**RESPONSE TO COMMENTS IN RELATION TO CONDITION 8 OF
PLANNING APPROVAL REF:
EML-OUT/20-030/C/20221111-90744-991**

As part of the Planning Application EML-OUT/20-030/C/20221111-90744-991, Ridge and Partners Prepared a Flood Risk and Drainage Strategy report for the proposed extension to Gorton Education Village to provide educational premises (Use Class F1); involving new building, landscaping, car parking and servicing.

**BOWKER SADLER ARCHITECTS,
MELLAND HIGH SCHOOL – GORTON EDUCATION VILLAGE**

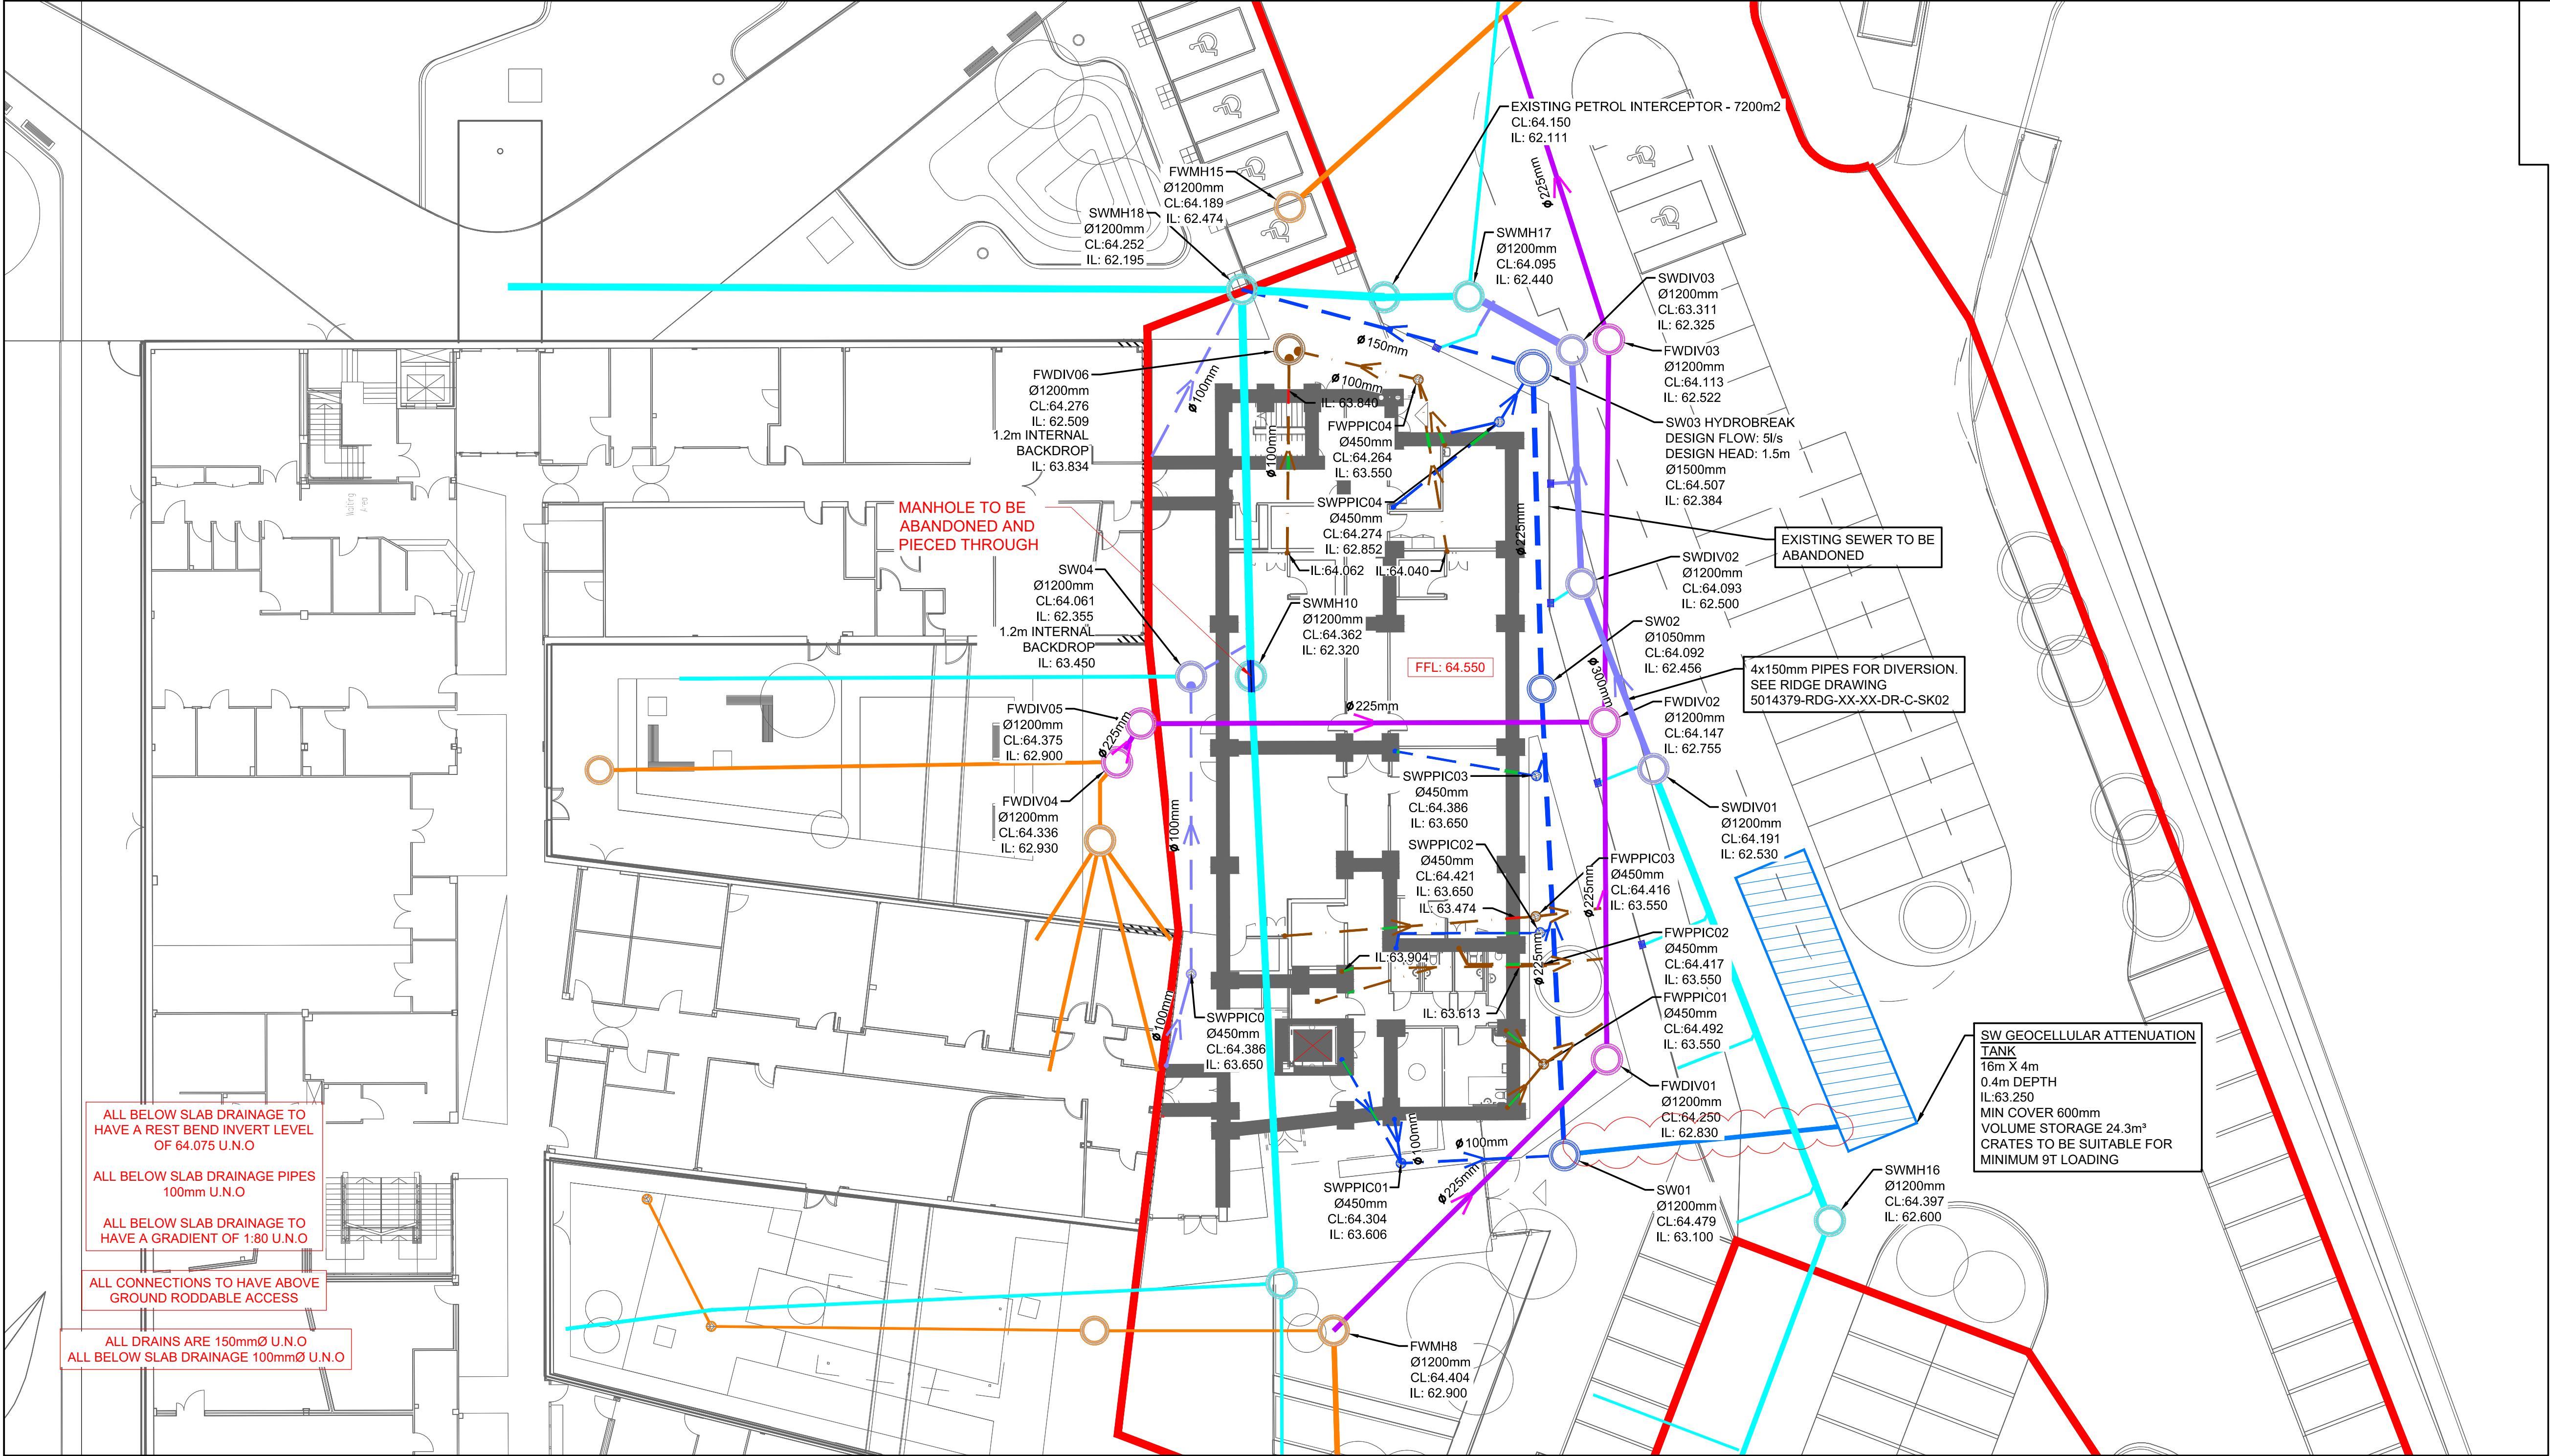
LLFA Comment	Ridge Response
<i>The information contains updated calculations which now indicate flooding in the 100+CC event. There is no flooding in the 100+CC event under the Planning Portal CDN/22/0551 drainage strategy; we would require further information to support why the system's performance has changed.</i>	Ridge accept this response. The inlet pipe on the attenuation tank has been upsized from a 100mm diameter pipe to a 225mm diameter pipe to allow the flow of water during the more intense storms to do so more easily and ensure the full storage capacity of the attenuation tank is fully utilised.
<i>The preference should be to contain this volume within the network where feasible.</i>	This change ensures that the volume of water present in the 100 year + 40% climate change allowance storm is contained within the network.
<i>If the flooded volume in the 100+CC cannot be contained within the network, we require further evidence that the flows can be managed onsite.</i>

<i>The overland flow layout would need to be supported with evidence of proposed topo levels to demonstrate that the flows will be contained as-shown and that the flooded volume would not present an issue to the applicant as this is shown to affect a dropoff bay and 'formal entrance' according to the 132456/FO/2021 masterplan.</i>	As such, the dropoff bay and 'formal entrance' are no longer at any risk of flooding from any flooded volume. The general arrangement drawing & drainage model have been updated to suit this change (Appendix A & Appendix B respectively.)
--	--
